**SUBJECT: REPORT OF CONFIRMATORY ACTIVITIES FOR THE QUIVIRA MINING COMPANY-AMBROSIA LAKE FACILITY WINDBLOWN TAILINGS DECOMMISSIONING PROGRAM, GRANTS, NEW MEXICO (DOCKET NO. 40-8905; RFTA NO. 99-041)**

**REPORT OF CONFIRMATORY ACTIVITIES FOR THE  
QUIVIRA MINING COMPANY-AMBROSIA LAKE FACILITY  
WINDBLOWN TAILINGS DECOMMISSIONING PROGRAM  
GRANTS, NEW MEXICO**

FIGURE 7: Quivira Mining Company – Measurement and Sampling Locations

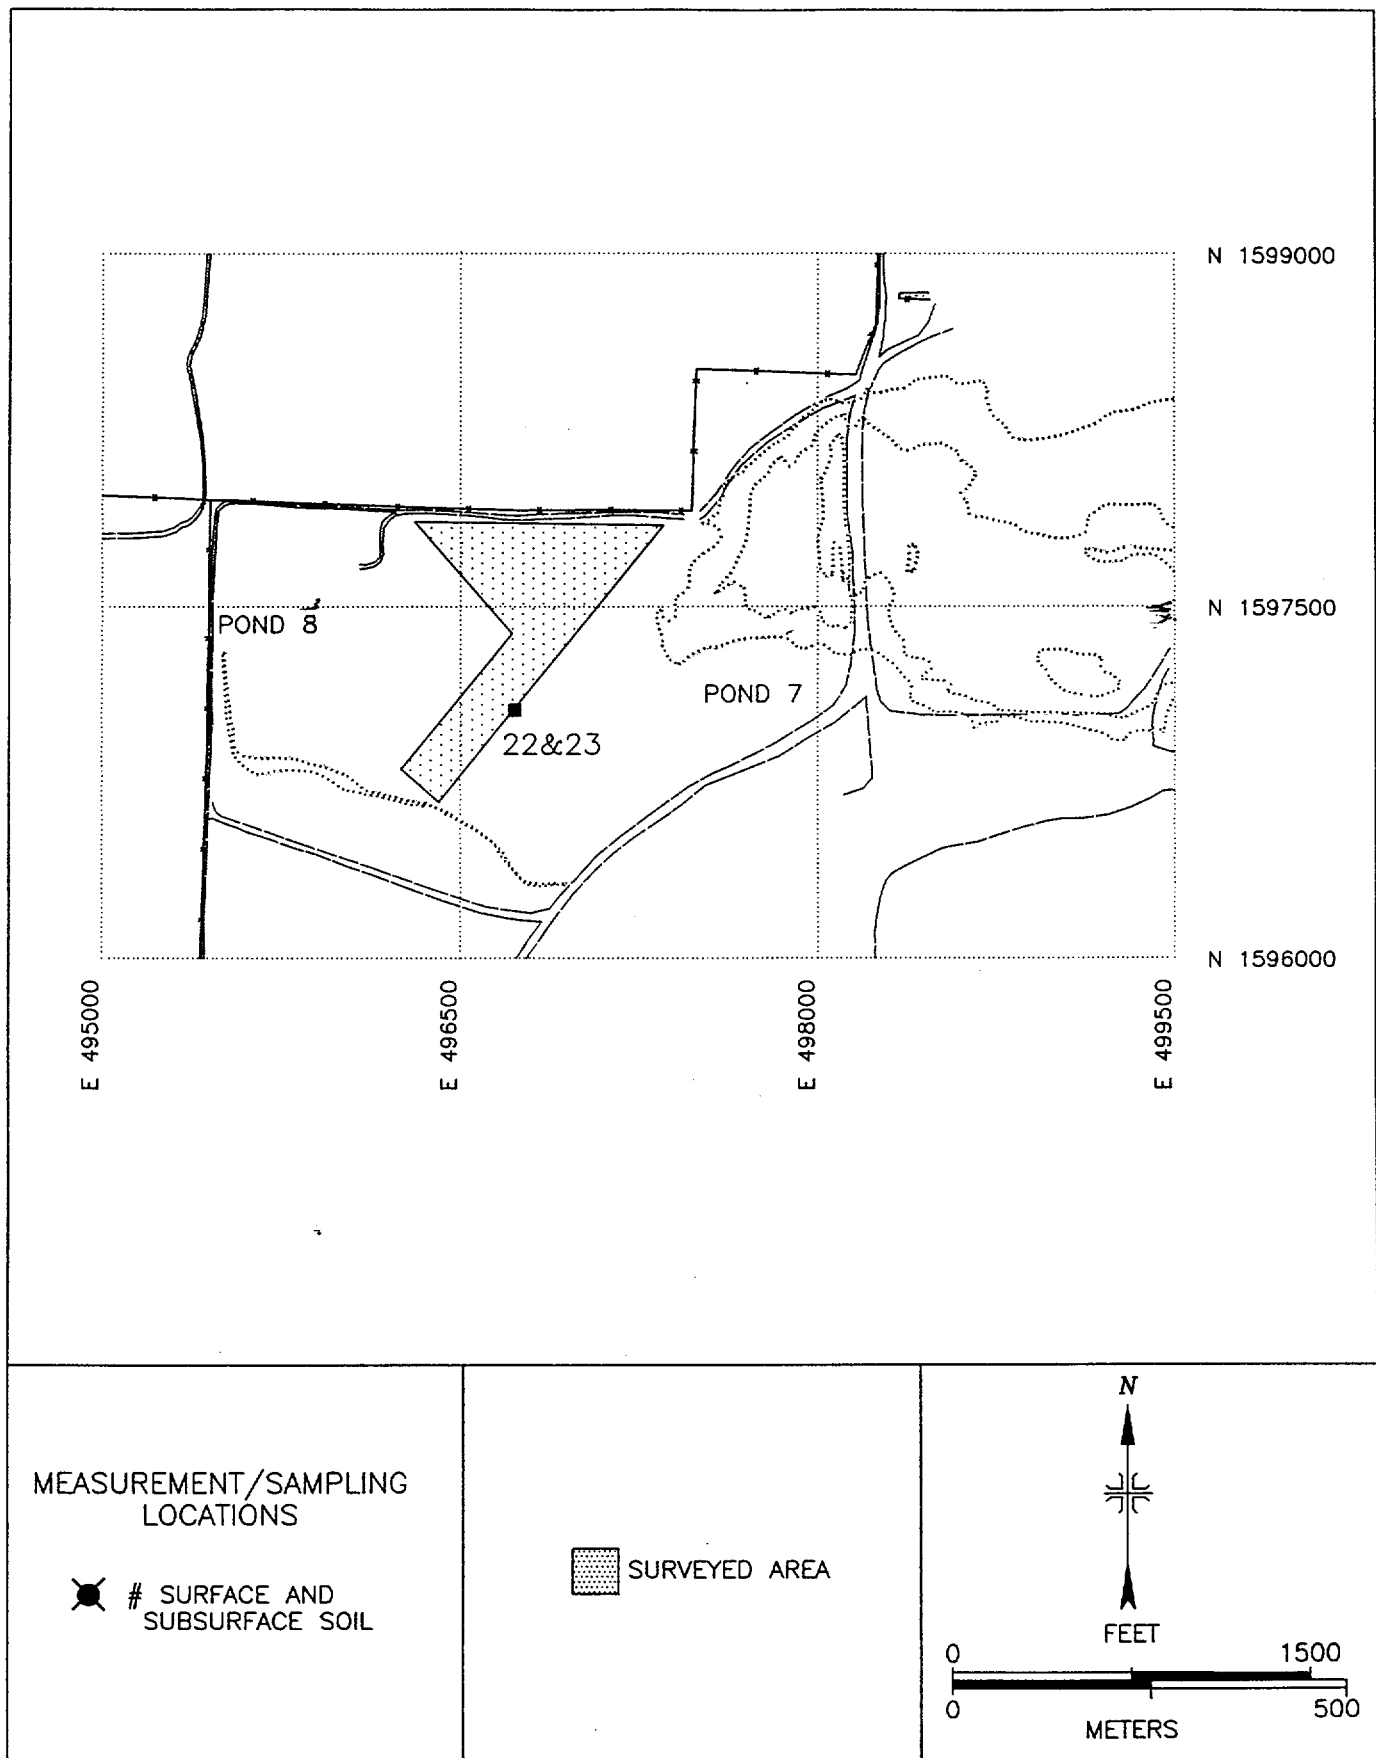
- Confirmatory gamma surveys were performed over four windblown tailings areas. Surveyed areas are shown on Figures 4 through 7. Surveys of these areas consisted of gamma surface scans using NaI scintillation detectors coupled to ratemeters with audible indicators. The distance between the detector and the ground surface was maintained at a minimum—nominally about 10 centimeters. Within each area surveyed, parallel one meter-wide detector scan paths were traversed for the entire length of the area. Scan paths were walked at intervals of every 10 to 20 meters across each surveyed area. Areas of elevated direct radiation in excess of the ambient background by a factor of greater than two times were marked and 100 % of the surrounding area was scanned. There were numerous such areas identified while performing the gamma scans. Sixteen representative anomalous areas identified were then selected for soil sampling. Samples were collected from the center of each selected anomaly and from four points equidistance between the center and what would be the corners of a 10 m × 10 m area, and field composited. Within Ponds 4, 5, and 8, general area gamma measurements were made while traversing each pond from end-to-end. General elevated gamma activity up to 10 times ambient background was noted throughout each of the ponds. Composite soil samples as described above were collected from three locations each in Ponds 4 and 5. For Pond 8 which had been remediated and backfilled, a composite sample was collected from one location at the surface (0 to 15 cm) and then a composite subsurface (15 to 30 cm) sample collected. Figures 5 through 7 show soil sampling locations. Exposure rate measurements were determined not to be required with the NRC representative's concurrence.
